ADDENDUM # 001

PROJECT: Perley Elementary School Partial Roof Replacement

CBI JOB NO.: 14147

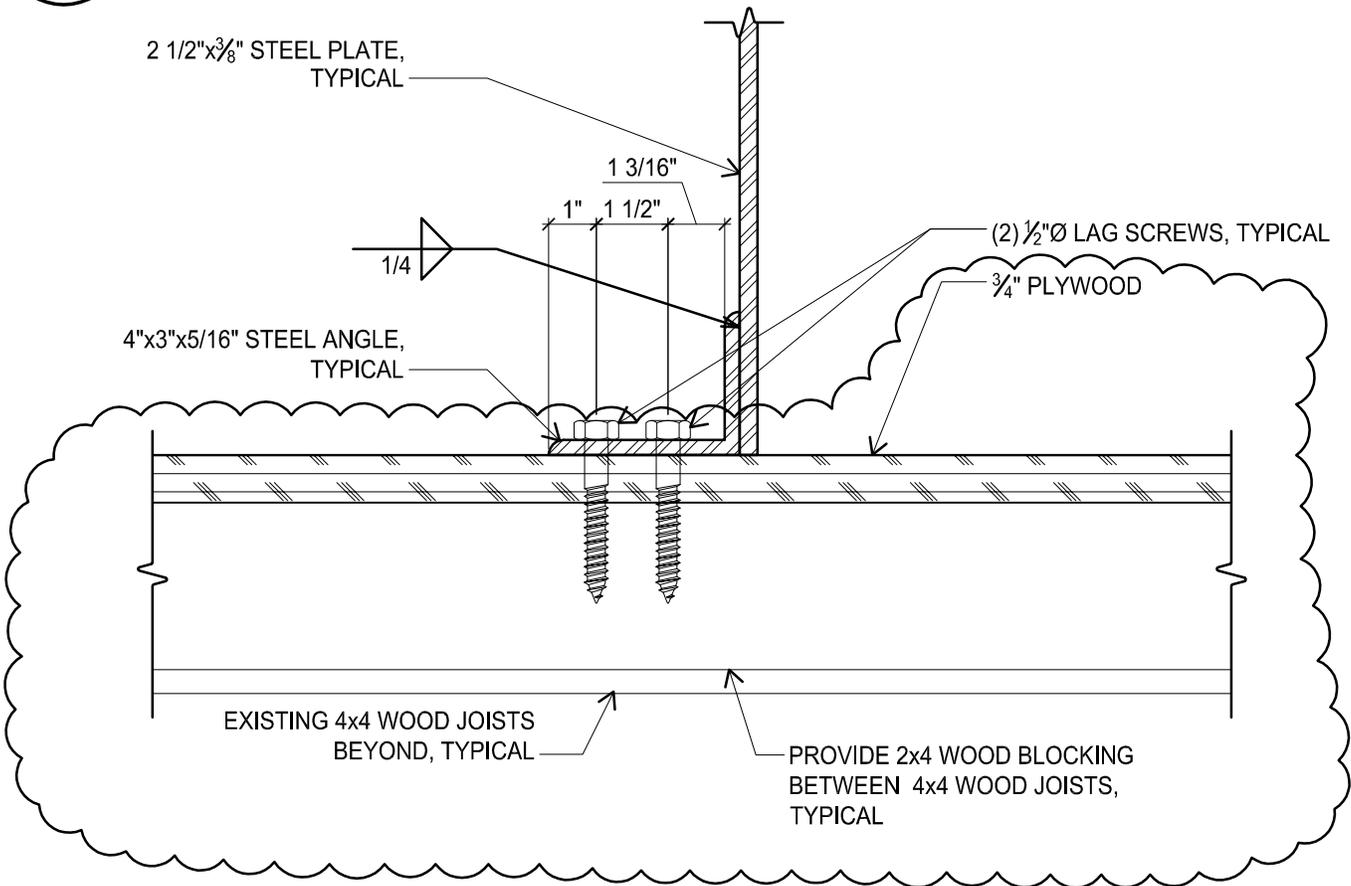
- 2.1 Sheet A2-04
- 2.1.1 Modify Details 4/A2-04, 5/A2-04 and 9/A2-04 to show attic space floor infill below ladder.
- a. See attached sheets SK-1, SK-2, SK-3 and SK-4 for the information.

2 **EXISTING ATTIC FLOOR AREA TO BE FRAMED**
 SCALE: 3/4" = 1'-0"

1 **LADDER BASE CONNECTION DETAIL**
 SCALE: 3/4" = 1'-0"
